Drinking Water Audit Report

County:	Galway	Date of Audit:	31 st August 2016
Plant visited:	Glenamaddy Water Treatment Plant (scheme code 1200PUB1021)	Date of issue of Audit Report:	30 th September 2016
		File Reference:	DW2009/184
		Auditors:	Aoife Loughnane Emer Cooney
Audit Criteria:	<ul style="list-style-type: none"> • The <i>European Union (Drinking Water) Regulations 2014 (S.I. 122 of 2014)</i>. • The <i>EPA Handbook on the Implementation of the Regulations for Water Services Authorities for Public Water Supplies (ISBN: 978-1-84095-349-7)</i> • The recommendations specified in the <i>EPA Drinking Water Report</i>. • EPA Drinking Water Advice Notes No.s 1 to 15. • The recommendations in any previous audit reports.

Photo 3: HMI plant control settings showing 'Alarm Debounce Time' of 49 minutes

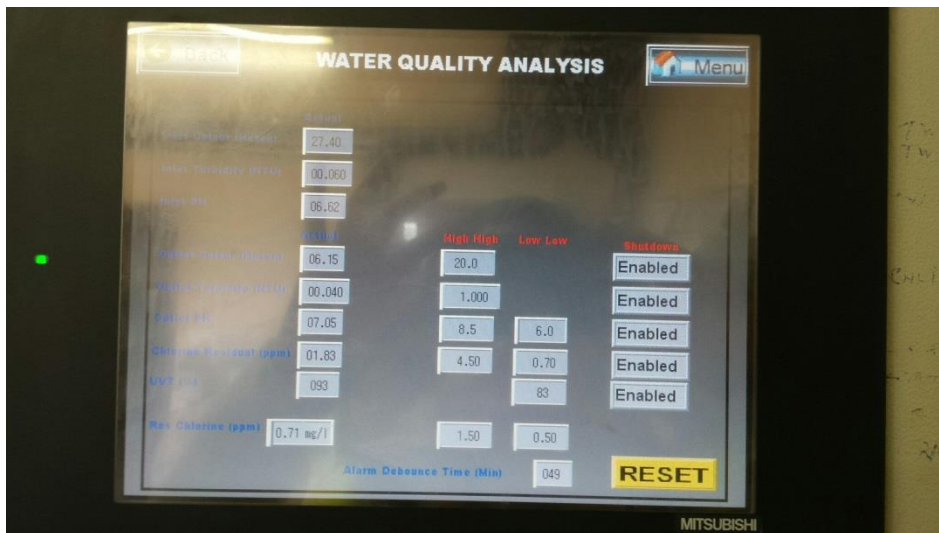
7.	<p>Management and Control</p> <ol style="list-style-type: none"> The final water is monitored continuously for colour, turbidity, pH and residual chlorine which were 6.15 Hazen, 0.04 NTU, 7.05 pH and 1.77 mg/l at the time of the audit. UV reactor control panel No. 1 was displaying a flow reading of 0.0 m³/hr during operation (see photo 2). However, the flow monitor in the plant control room displayed 20 m³/hr. The control set-points which activate an automatic plant shut-down are final water turbidity > 1 NTU, UVT < 83%, residual chlorine < 0.7 mg/l leaving the plant. The HMI screen shows an 'Alarm Debounce Time' of 49 minutes (see photo 3) which the caretaker believes to be the time delay before plant shutdown is activated. This significant delay before plant shutdown presents a risk to the final water quality. The current EDEN scheme data for Glenamaddy PWS identifies the population served as 1,206, volume supplied as 517 m³/d and level of treatment as "<i>ozonation, GAC filtration, UV, pH adjustment and chlorination</i>". During the audit, the operators identified that the population and volume figures are too high (they believe 370 m³/day is more accurate) and there is no pH adjustment carried out at the plant.

- (ii) there is minimum delay in automatic plant shutdown if the final water quality does not meet the required operating criteria.
4. Irish Water should investigate and rectify why the control panel on UV Reactor No. 1 was displaying no flow reading during operation.

3. Irish Water should review the plant control settings to ensure that:
 - (i) the alarm and automatic shutdown set-points on the UV disinfection system are appropriate to the validated operating criteria. The validated operating criteria should be clearly displayed and a copy of the UV certificate and validated operating characteristics should be kept at the plant.
